## SERVICE BULLETIN

### **Interface Unit IU-1507A Part Number 4001976-0751, -0752 and -0753 Unit Mod 24**

#### **Hardware Changes to Reduce EMI Radiation**

Figure 3 EMI Filter Wiring Diagram

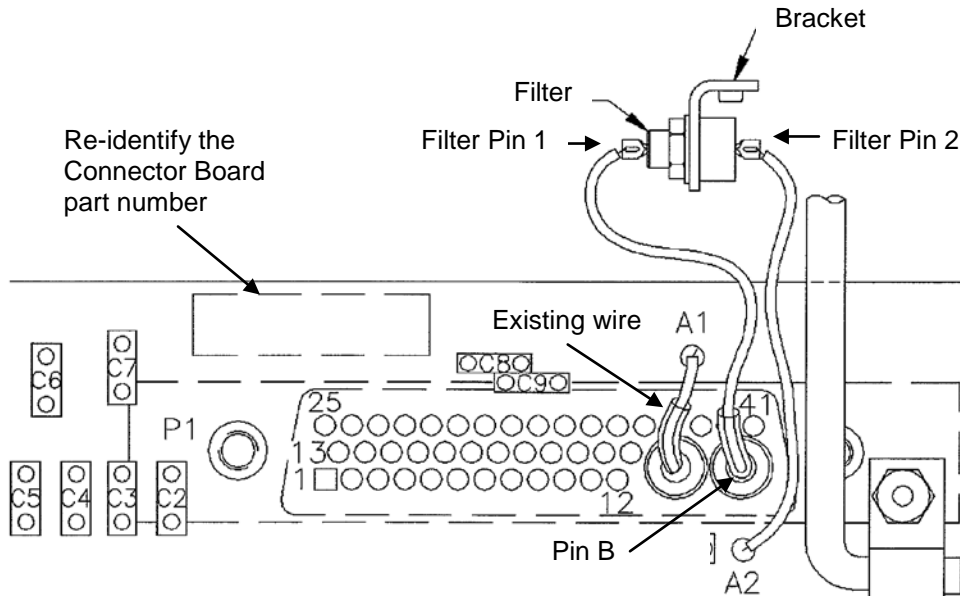
- 6 Using items 1 and 2 add two item 4 wires to connect the filter to the Connector Module.

- A) Retain the existing wire from P1 pin A to A1
  - B) Replace the wire from P1 pin B to A2 with a three (3) inch wire from P1 pin B to Filter pin 1.
  - C) Add a three (3) inch wire from P1 pin A2 to Filter pin 2.
  - D) Use a sharp blade remove the numeral "2" from the existing part number 8057127-0502. Using black ink, replace the numeral "2" with the numeral "3" so that the new part number now reads 8057127-0503. Allow the ink to dry thoroughly before assembly of the connector module to the front panel.
7. Re-assemble the Connector Module to the Front Panel.

Figure 4. EMI Filter Installation

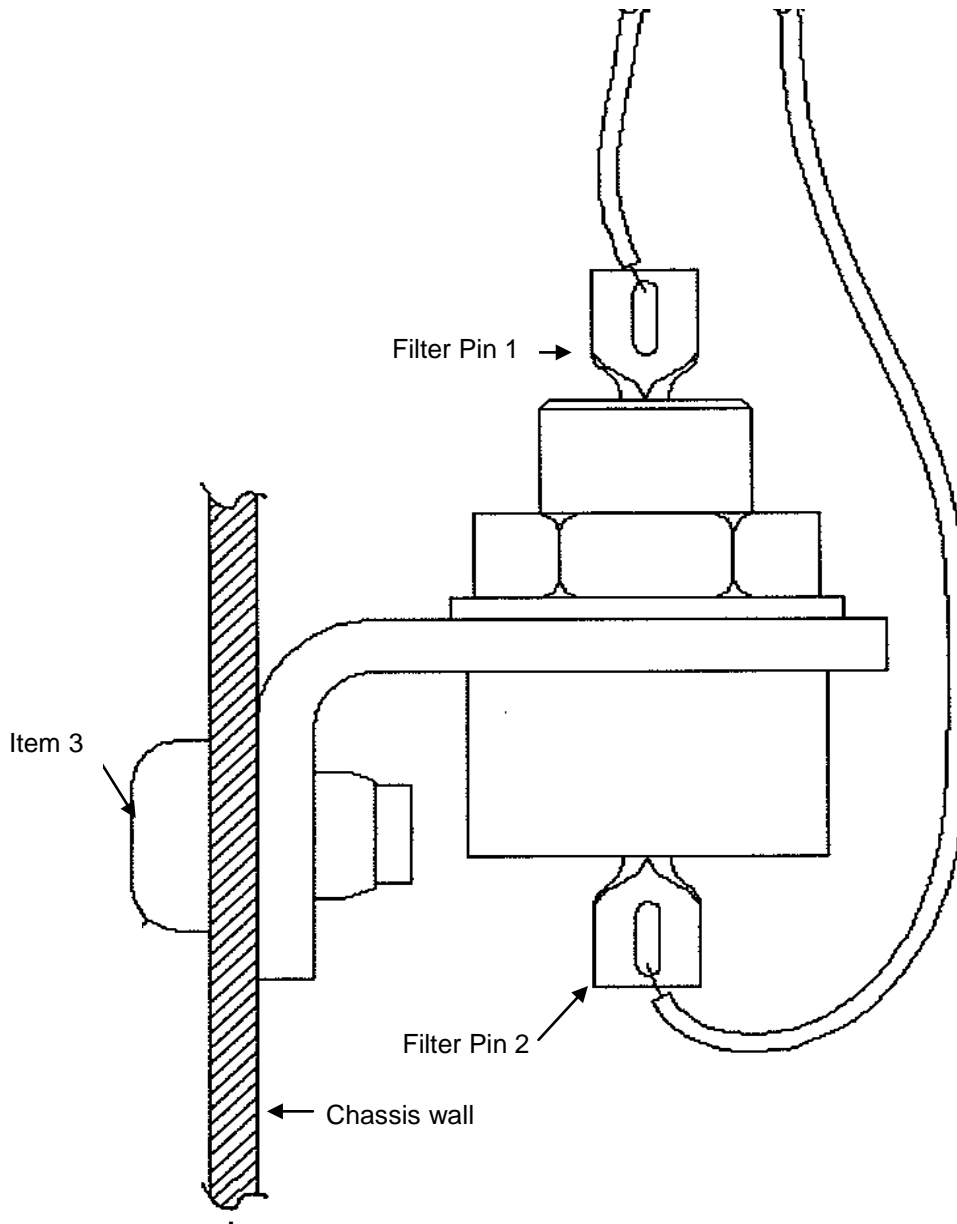
- Using two (2) item 3 screws attach the filter assembly to the chassis wall as shown in Figures 4 and 5.

Figure 5. EMI Filter Installation Location

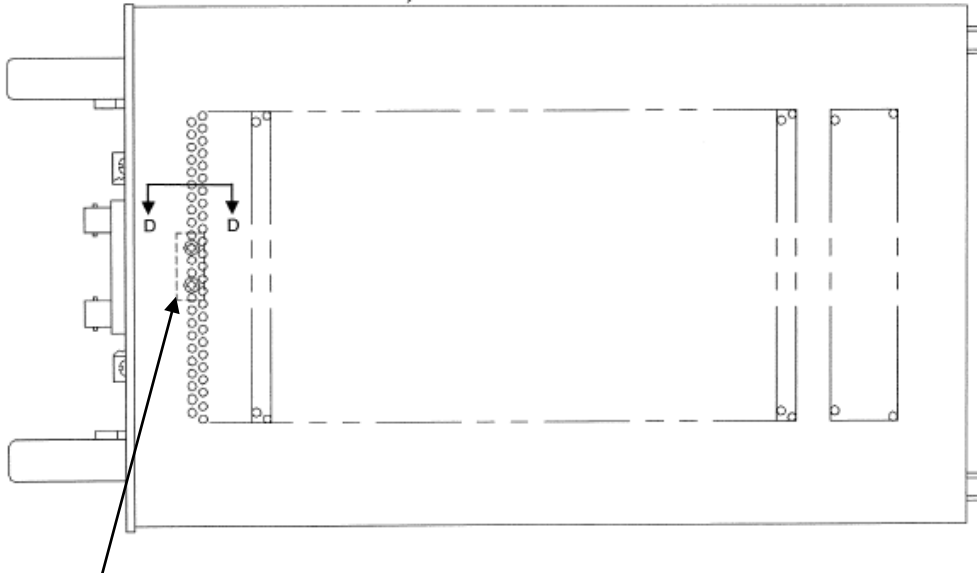
9. Figure 5 shows the mounted position of the filter.

Filter inside  
mounted  
here

Figure 7. Front Panel

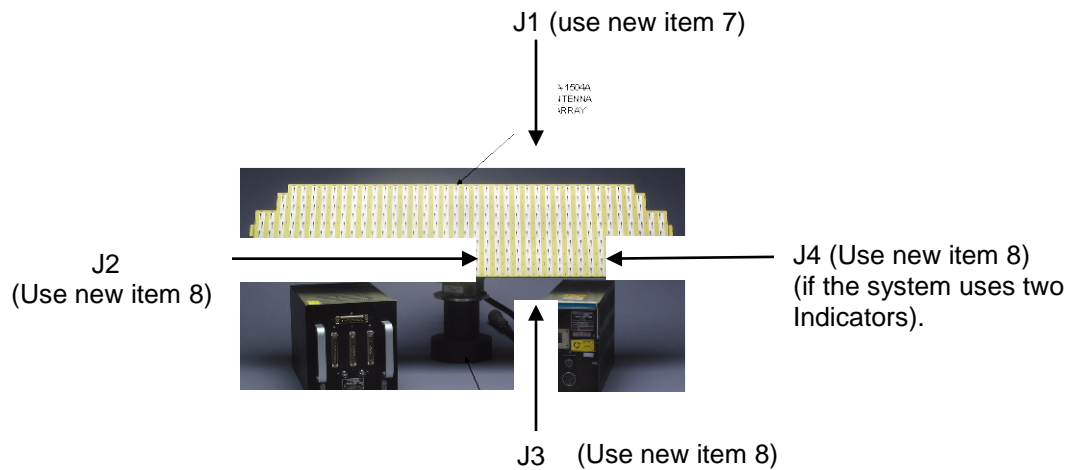
13. On the system cables, replace the existing plastic cable hoods with metal hoods. Follow the instructions shown in Figure 7. The plastic hood is removed by unfastening four (4) screws.
14. The system cables shall be over-braded with shielding that has 90% coverage. This shielding shall extend to and attach to the metal hoods of the connectors. Splicing of the shield shall have an overlap or one (1) inch minimum.
